STAFF RECOMMENDATION
1808 Holly Street
June 17, 2020

Application: New Construction—Infill
District: Lockeland Springs-East End Neighborhood Conservation Zoning Overlay
Council District: 06
Base Zoning: R6
Map and Parcel Number: 08314006500
Applicant: Joyce Jordan
Project Lead: Sean Alexander, sean.alexander@nashville.gov

<p>Description of Project: A proposal to construct a new duplex, replacing a duplex structure that was demolished by the tornado on March 3rd. The new building will be two-stories tall, as was the previous building.</p> <p>Recommendation Summary: Staff recommends approval of the proposed two-story duplex construction at 1808 Holly Street with conditions that:</p> <ol style="list-style-type: none"> 1. The finished floor height shall be consistent with the finished floor heights of the adjacent historic houses, to be verified by MHZC staff in the field; and 2. The front setback shall be consistent with the setbacks of the adjacent historic houses, to be verified by MHZC staff in the field; and 3. The roof pitch shall be increased to between 5/12 and 6/12; and 4. Additional windows shall be added on the side elevations of the building; and 5. The window and door sel

ROOF PLAN

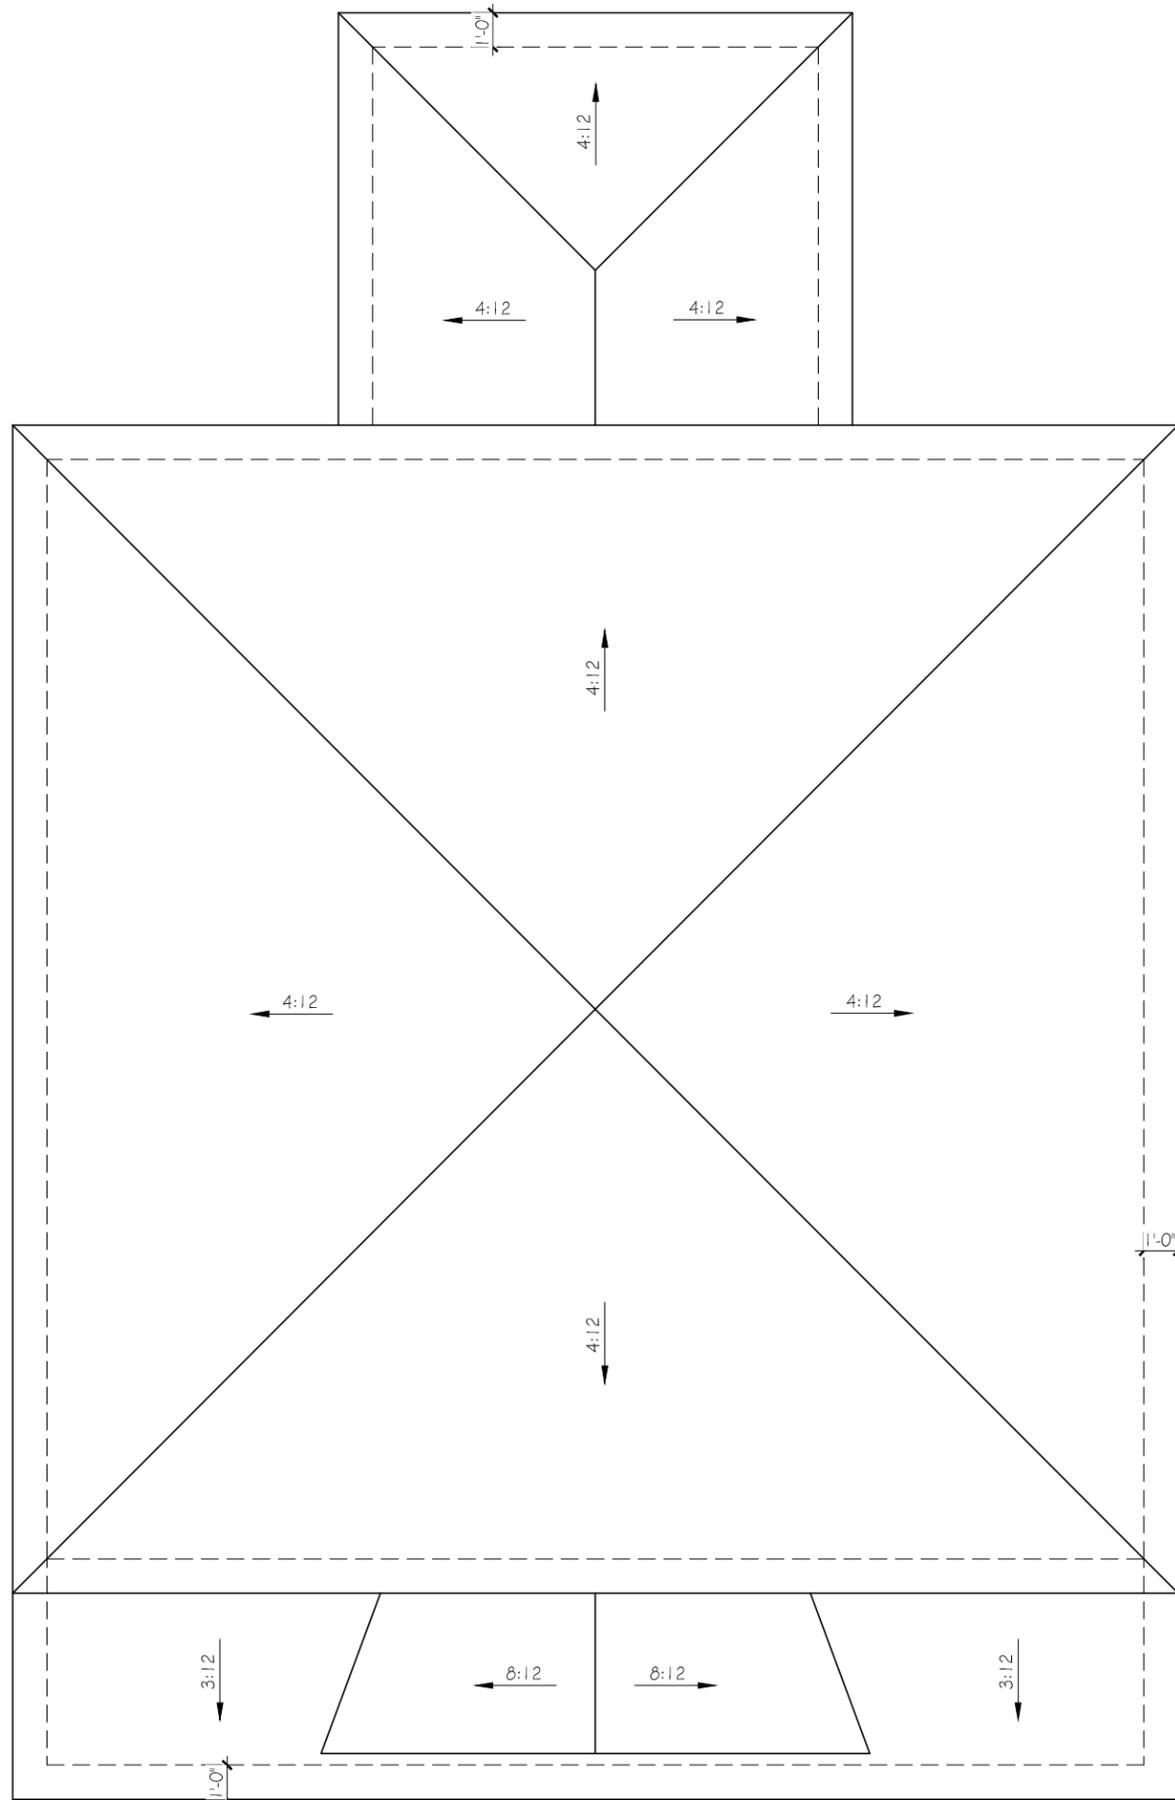
Roof form: The primary roof of the building will be hipped with a pitch of 4/12, and the front porch will have a full-width shed roof with a 3/12 pitch and a front-facing gabled accent with a pitch of 6/12. The primary roof pitch is lower than is typical for historic houses nearby. Staff recommends that the pitch be increased to between 5/12 and 6/12 which is more compatible with existing roofs nearby. This will increase the ridge-height of the building, but will still be compatible with the heights of historic houses nearby.

With a condition that the roof pitch shall be increased to between 5/12 and 6/12, staff finds the roofs of the proposed buildings to be compatible with surrounding houses and finds that the project will meet section II.B.5 of the design guidelines.

LEFT SIDE ELEVATION

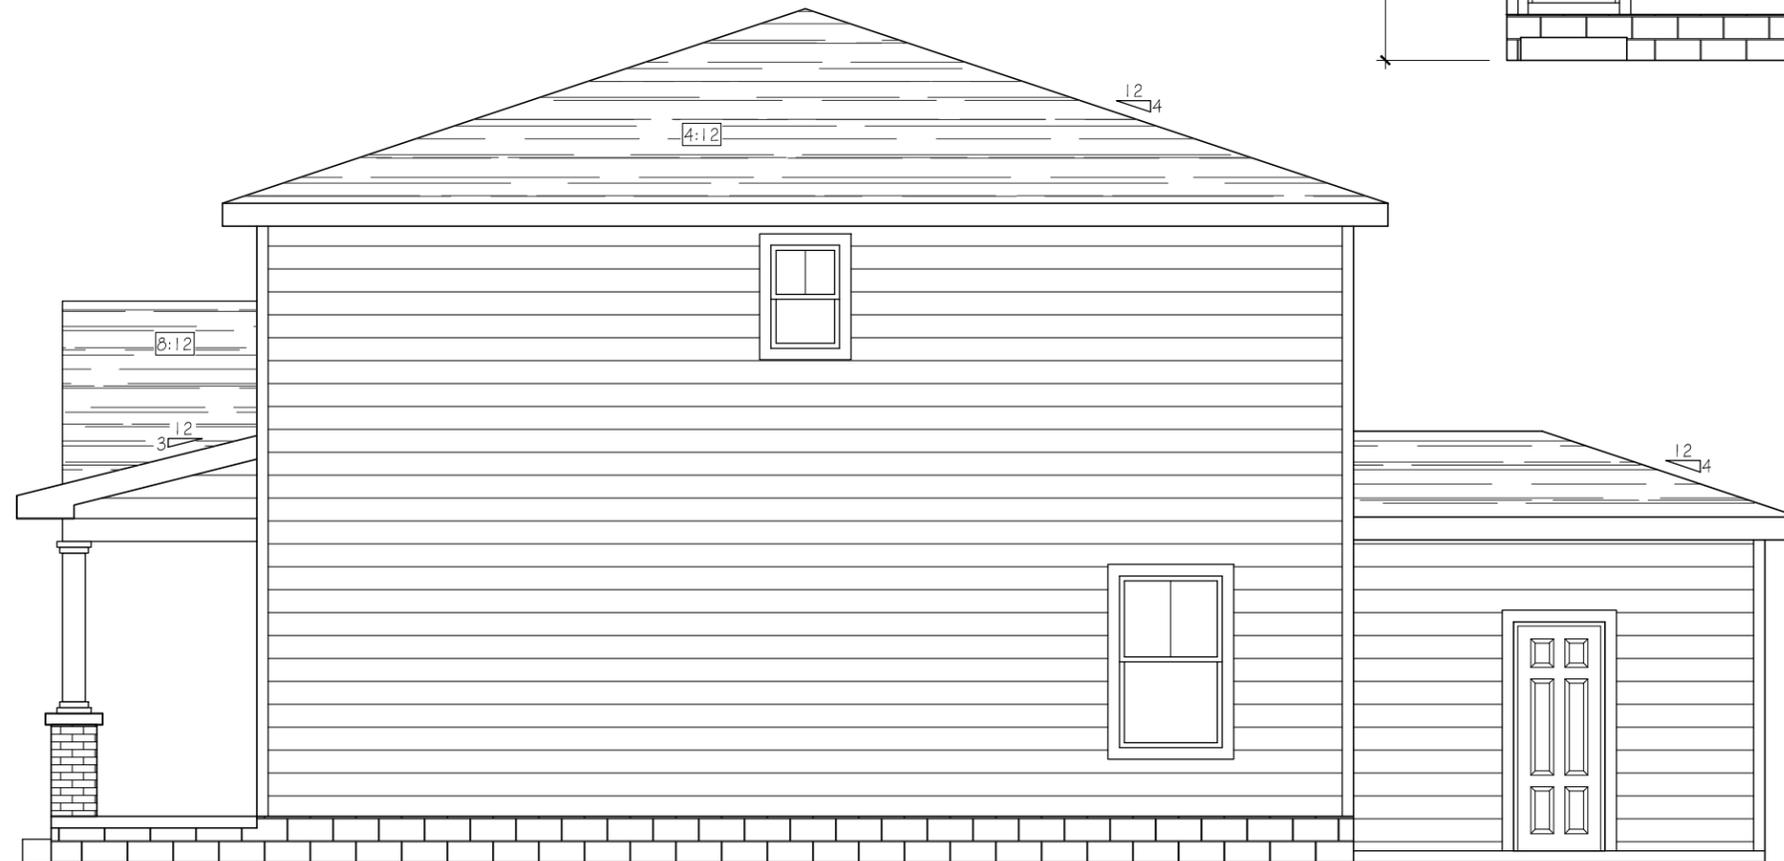
Proportion and Rhythm of Openings: There will be four pairs of double-hung windows on the front, two on each story, in a rhythm consistent with historic houses. The side elevations will have one window on each story, located at or behind the midpoint of the building. Typically, historic houses in the area have window openings roughly every ten feet (10'), with vertically oriented windows. Staff finds that additional windows are needed on the side elevations to be compatible with the historic context.

With a condition that additional windows, with similar proportion and rhythm of spacing are added to the side elevations, staff finds that the proposal will be compatible with the surrounding context and that the project will meet section II.B.7 of the design guidelines.
